Addendum No. 2

Contract No.: DA00198 TIP No.: BD-5101N WBS No.: 45347.3.FD15

Replacement of Bridge #18 Over Charles Creek on SR 1269 (South Road Street).

GENERAL DRAWING

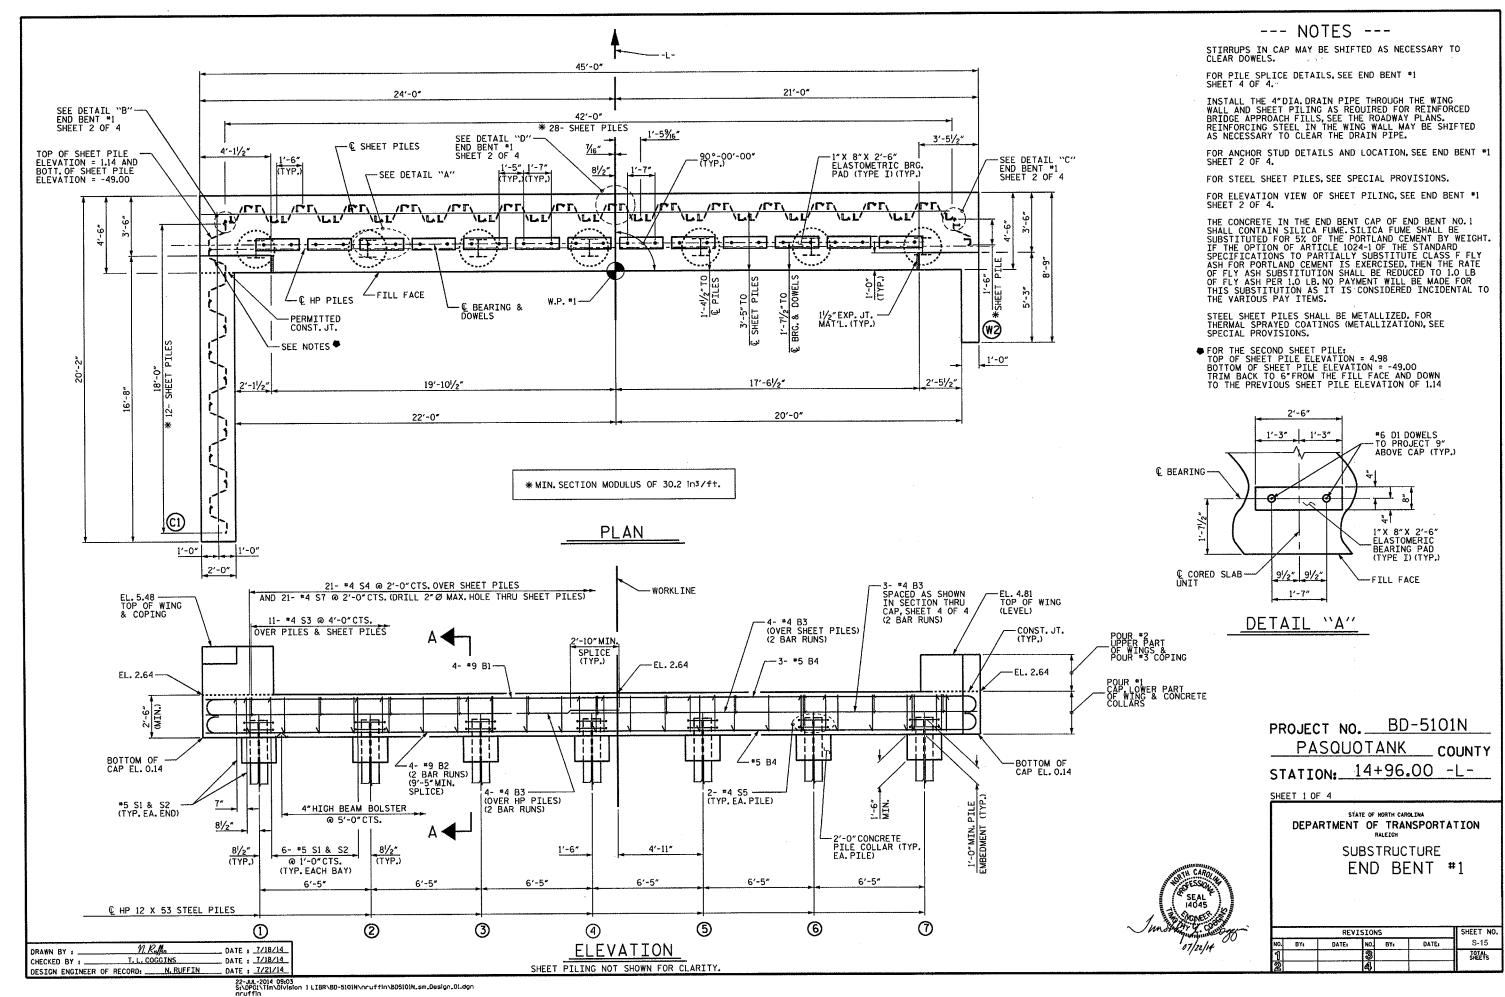
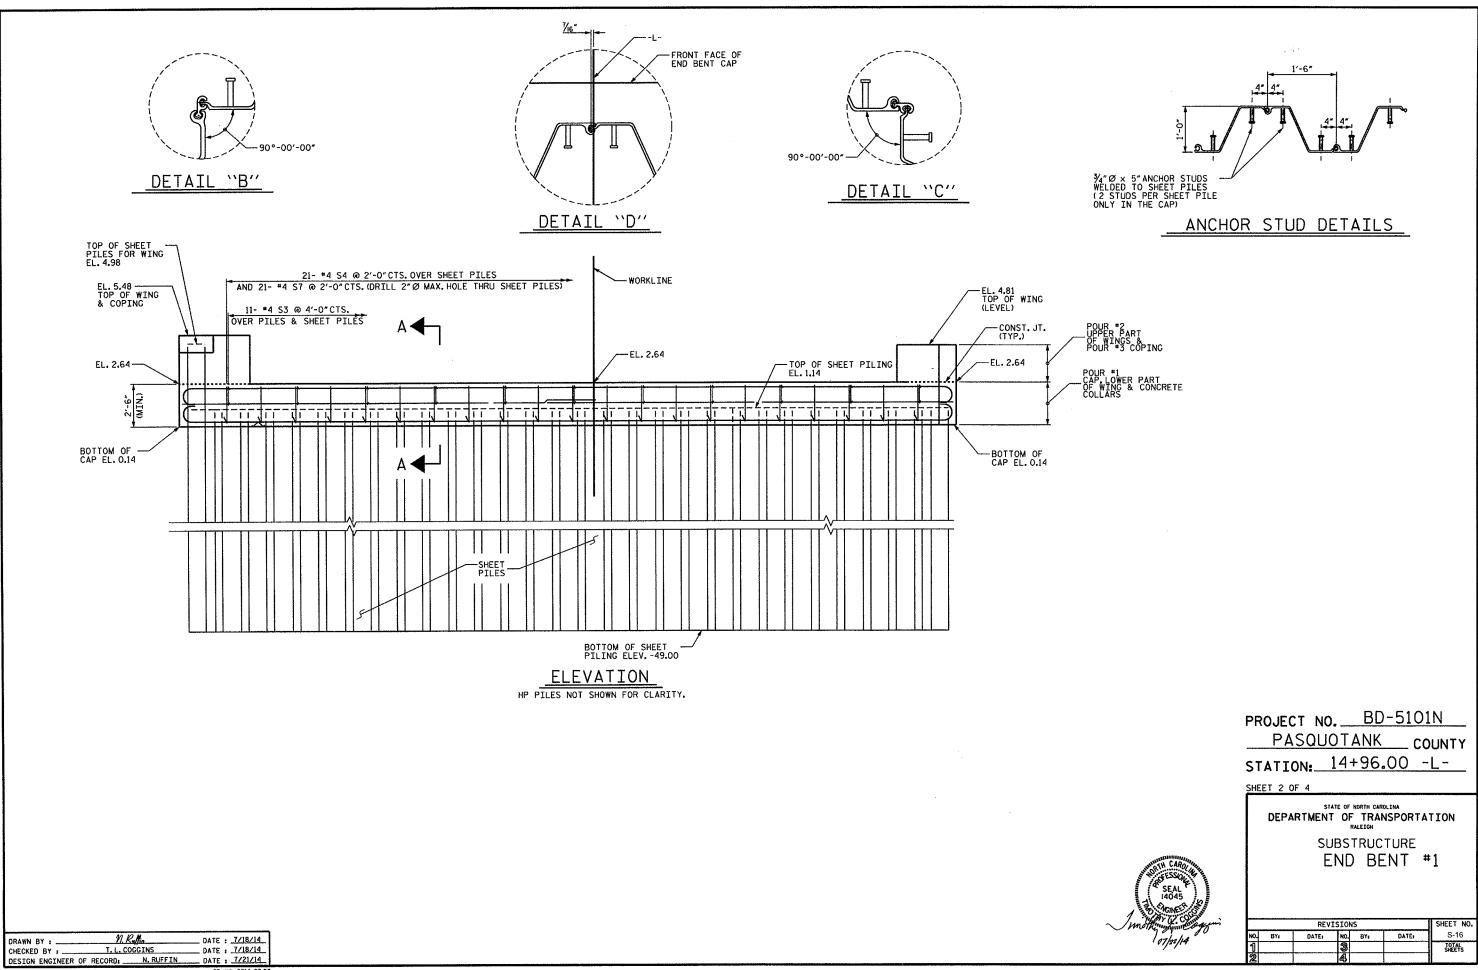
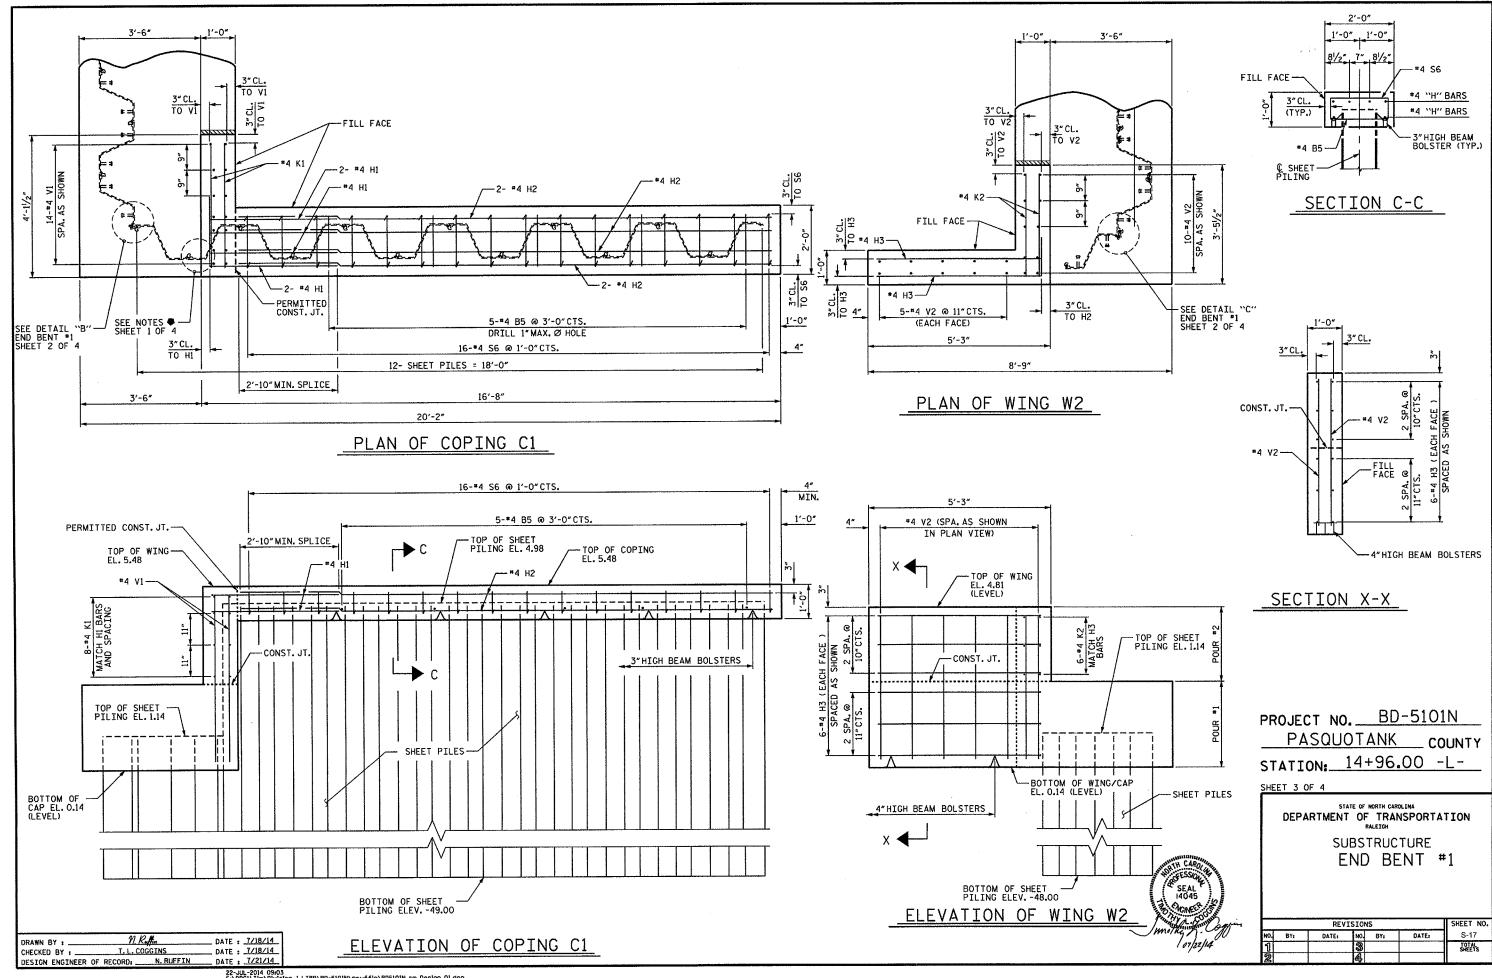
The attached Structure Plan Sheets have been revised to illustrate the changes in the retaining wall construction and show a section modulus of 30.2 in\*3/ft. Please void existing Structure Plan Sheets and staple the revised Structure Plan Sheets thereto.

STEEL SHEET PILES AT END BENT NO. 1 AND END BENT NO. 2 SHALL HAVE A MINIMUM SECTION MODULUS OF 30.2 IN3/FT.

STEEL SHEET PILES AT END BENT NO.1 AND END BENT NO.2 SHALL BE INSTALLED TO A SHEETING TIP ELEVATION OF -49.0 FEET.
